Submissions Report

6 Grand Avenue, Rosehill

SSD-55522478

MARCH 2024

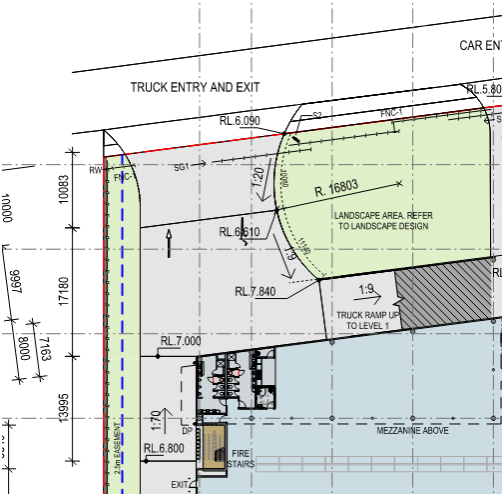
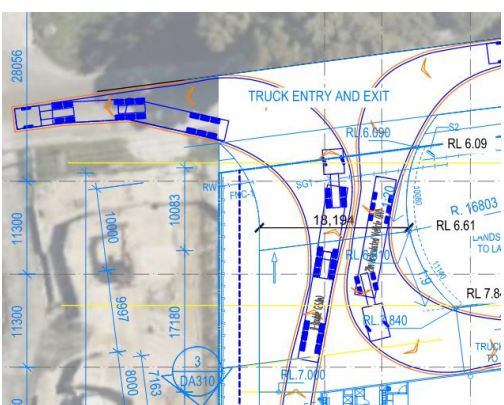
Component	Amendment
<i>Façade/Elevations</i>	Warehouse exterior walls to the east and west have been revised to include horizontal high contrast colour bandings and vertical dynamic elements, through the addition of glazed window strips with deep set framing and louvres.
<i>Landscaping</i>	The western driveway width has been reduced to accommodate an increased the landscape strip of 4.9m wide on the western boundary enabling extensive sections of deep soil planting. This permits additional planting, with large canopy trees are proposed.
<i>Public Domain</i>	Plans have been updated to demonstrate future public domain works can accommodate footpaths, driveway crossovers (proposed with the development), street trees and bus stops.
<i>Westernmost driveway</i>	The westernmost driveway adjoining the Parramatta Light Rail Maintenance Facility has been amended to ensure the splay is wholly located within the frontage of the subject site and the revised swept paths have been updated.
